PRODUCT SAFETY NOTICE

LADDER SAFETY SYSTEMS USING 3/8 INCH 7X19 STRAND GALVANIZED CABLE

A top bracket assembly is depicted below, with diagrams and photos of **7x19** strand cable (affected) and 1x7 strand cable (not affected).

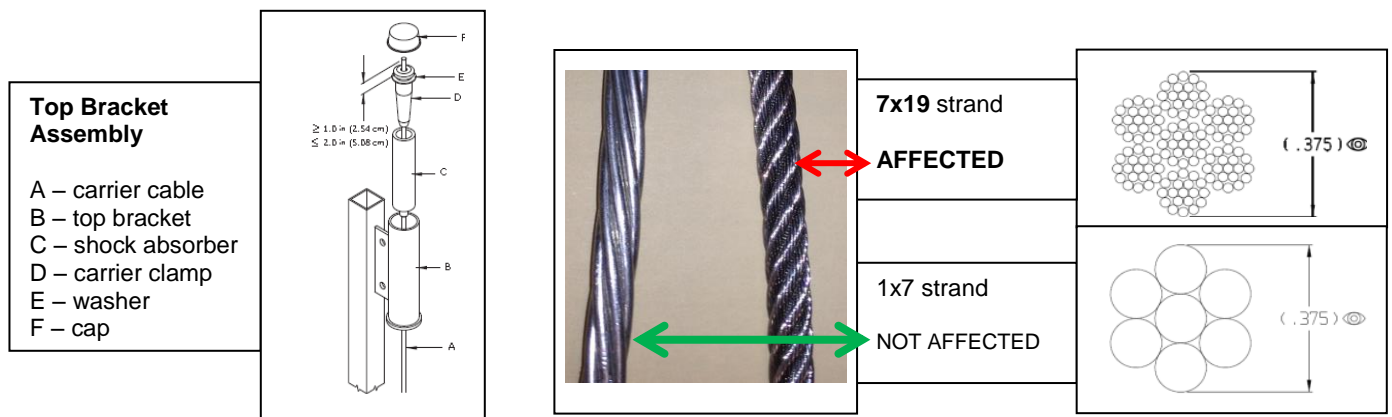
This Notice concerns the DBI-SALA Lad-Saf™ Flexible Cable Ladder Safety System, also known as a 'Safety Climb System.' Capital Safety has received a limited number of reports of **7x19** strand carrier cable slippage from the carrier clamp in the top bracket of these ladder safety systems. Although this top bracket design has been used in the market for more than 40 years without incident, the reported slippage raises the potential for injury to users of affected systems.

- **systems using 3/8 inch 7x19 strand galvanized cable, with**
- **top bracket assemblies (including carrier clamps) purchased from Capital Safety between September 1, 2013 and May 13, 2014**

- Top bracket assemblies purchased before September 1, 2013 or after May 13, 2014
- Ladder safety systems that use 1x7 strand cable

Capital Safety recommends that users: (1) inspect their systems prior to next use to determine whether 3/8 inch 7x19 strand cable is used and, if so, (2) determine whether the top bracket assemblies were purchased within the above date range.

If an affected Lad-Saf system or Safety Climb System is found, do not use the system until you have contacted Capital Safety Customer Service at 1-800-328-6146 (ext. 2012), or email us at csq.iss.inquiries@capitalsafety.com. We will answer inquiries and provide guidance on how to proceed.
